PROJECT: City of Mount Vernon E Section & S Laventure Traffic Signal

ADDENDUM NO. 1

**To the Contract Provisions for:
E. SECTION ST. AND S. LAVENTUE RD.
Project No. TS-2017-011**

E. SECTION AND S. LAVENTURE RD
TRAFFIC SIGNAL
PLAN AND PROFILE - E. SECTION ST

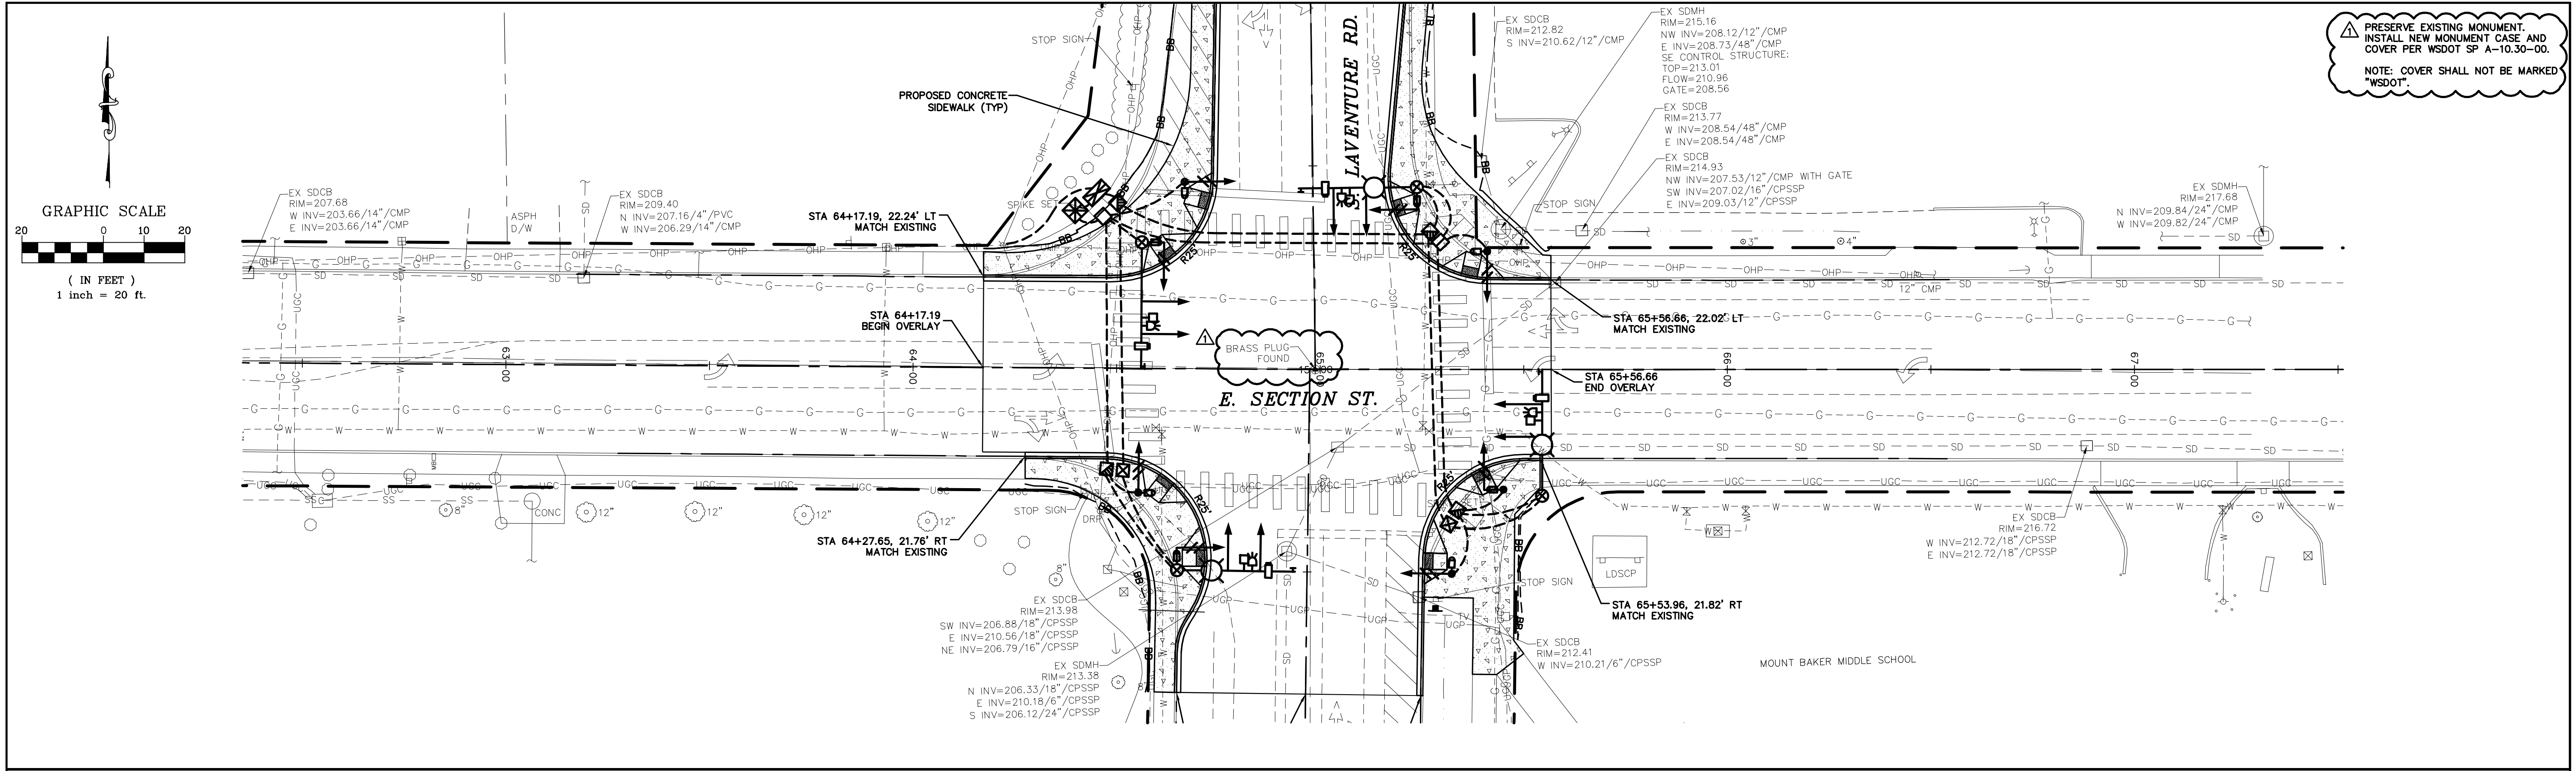
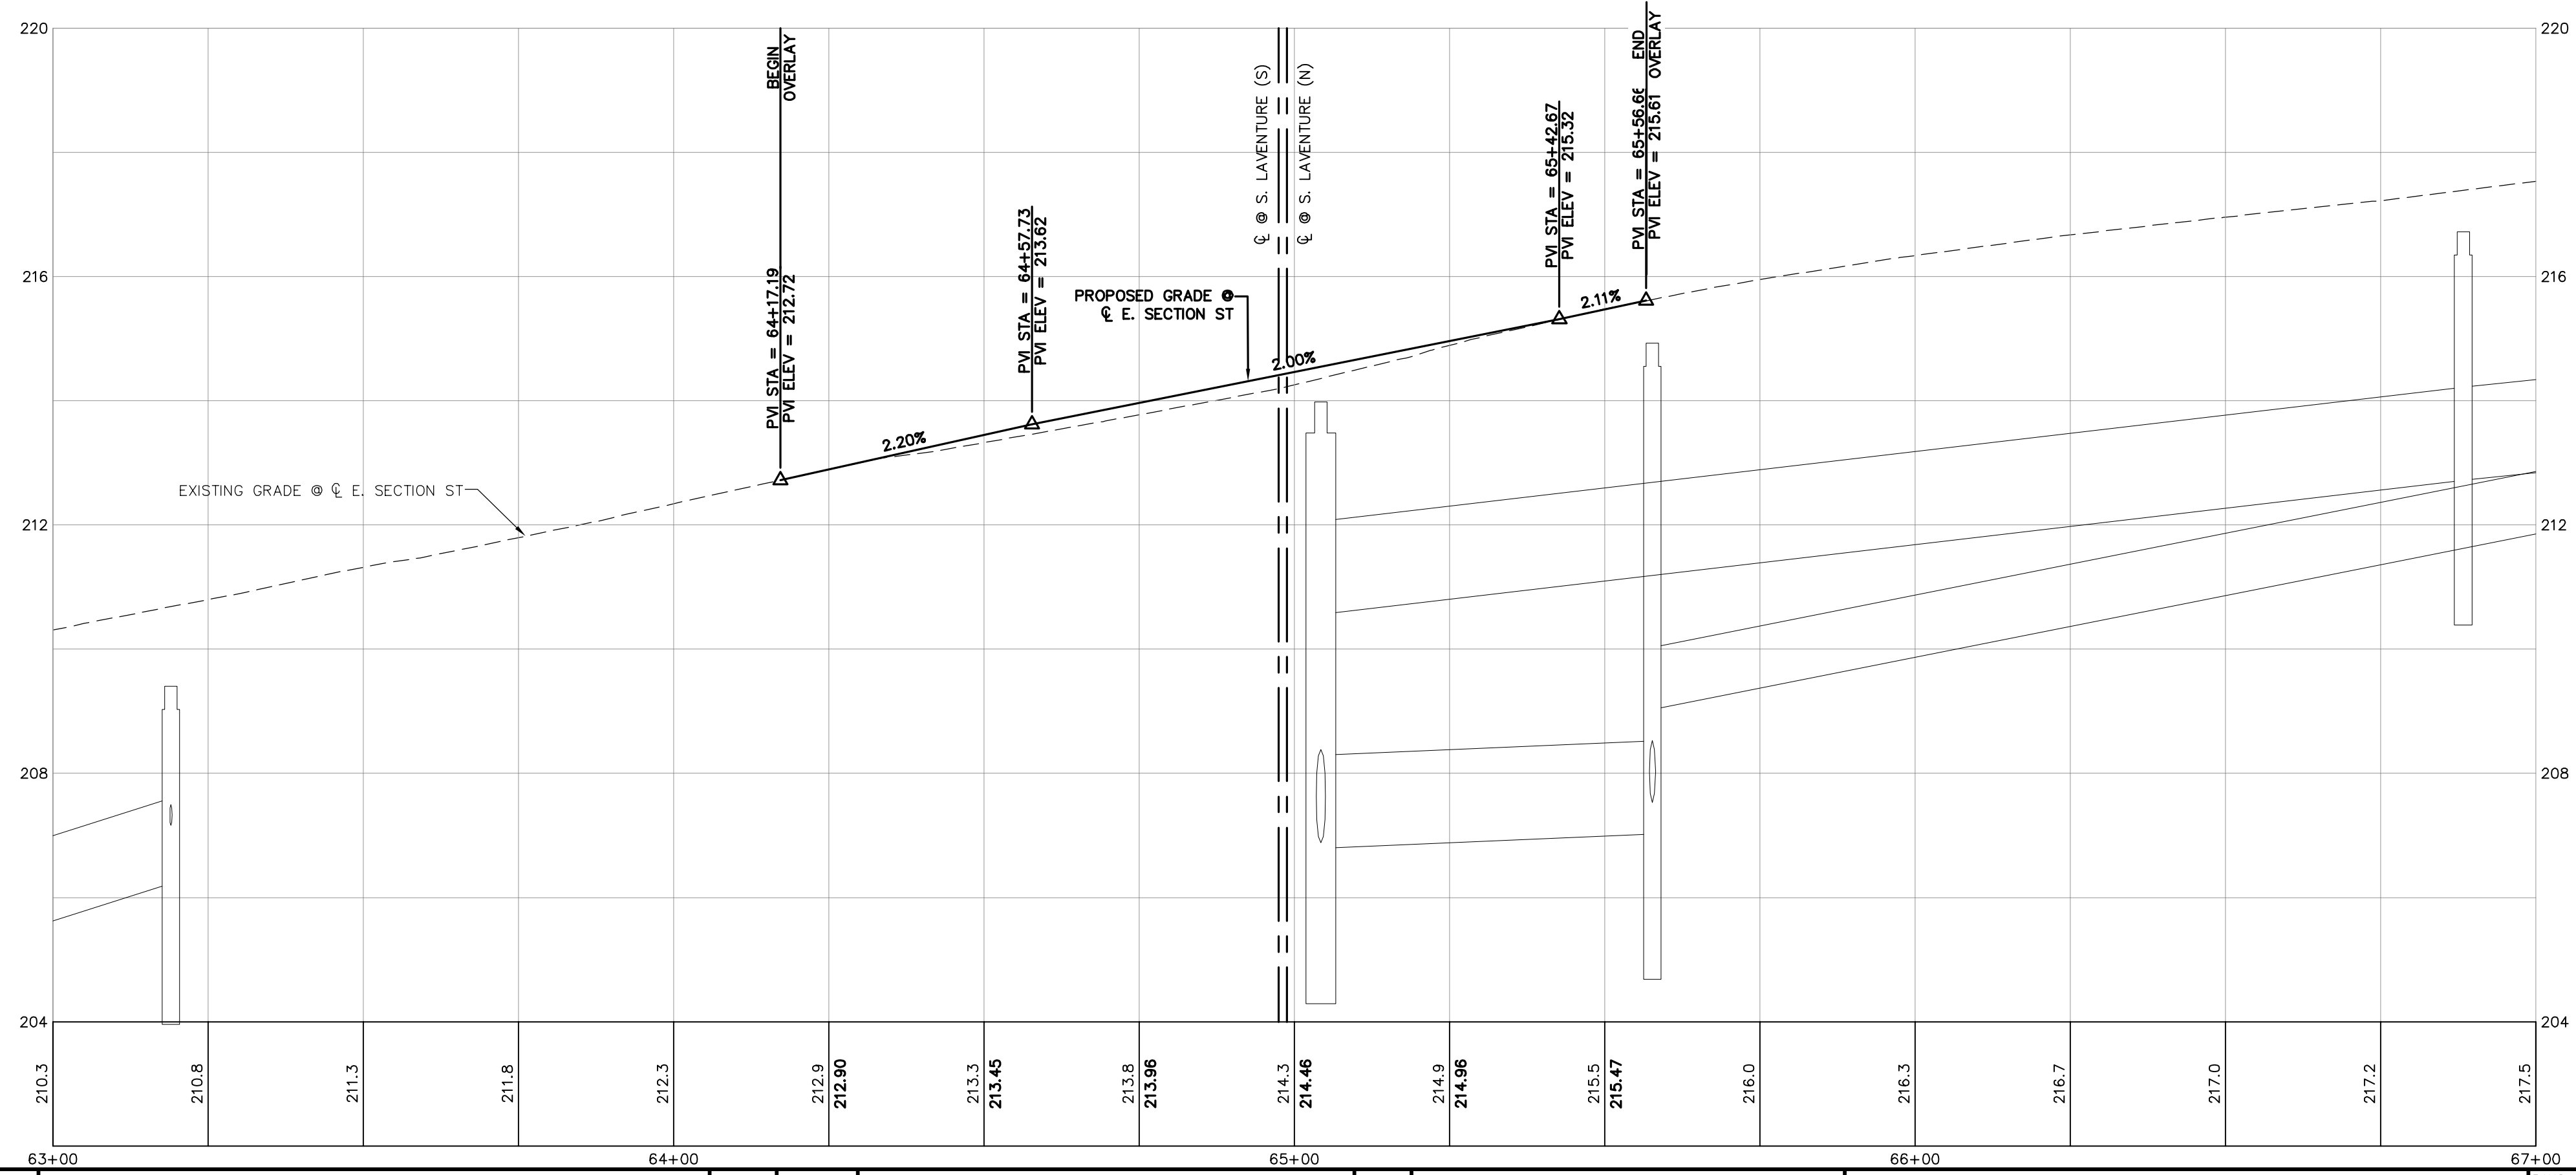
Plan sheet 5 is deleted and replaced with the attached revised plan sheet 5.

▲ PRESERVE EXISTING MONUMENT.
 INSTALL NEW MONUMENT CASE AND
 COVER PER WSDOT SP A-10.30-00.
 NOTE: COVER SHALL NOT BE MARKED
 "WSDOT".

NO.	DATE	DESCRIPTION	BY
1	5/1/17	ADDENDUM NO. 1 - PRESERVE MONUMENT	NZ
